Century Mine
American Energy Corporation
In GOD We Trust

RE: Response to Comments, Bennoc Area NPDES OIL00159 Application for American Energy Corporation in Belmont County, Ohio

Response to OEPA Comments from Bruce Goff and Eric Nygaard Dated 8/21/12, 8/15/12, 7/20/12, 7/13/12, and 7/11/12 Bennoc NPDES Permit Application OIL00159

Wheel treatment system – pictures provided by www.chemstream.com

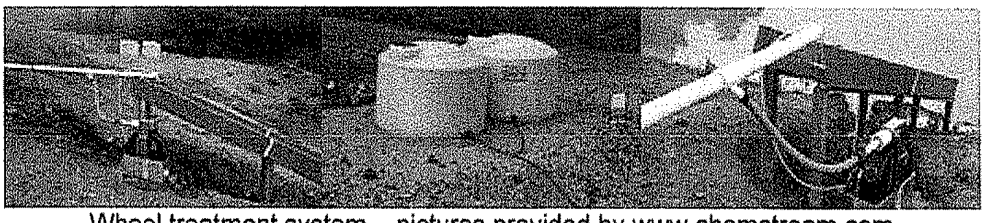
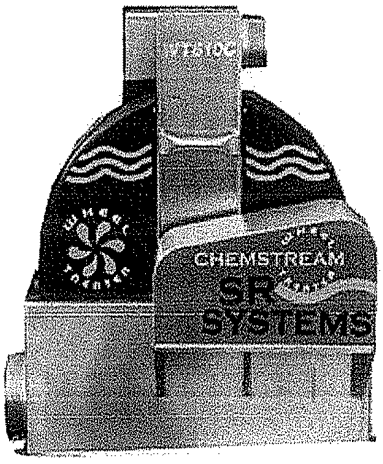
Comment: Do you happen to have any photos of the treatment ponds, the outlet structures, the chemical feed equipment and the discharge drainage ways (outlet ditches) you can share?

Response: We do not have any pictures of the proposed treatment ponds and their structures. However, we do have a picture (below) of the proposed wheel treatment system.
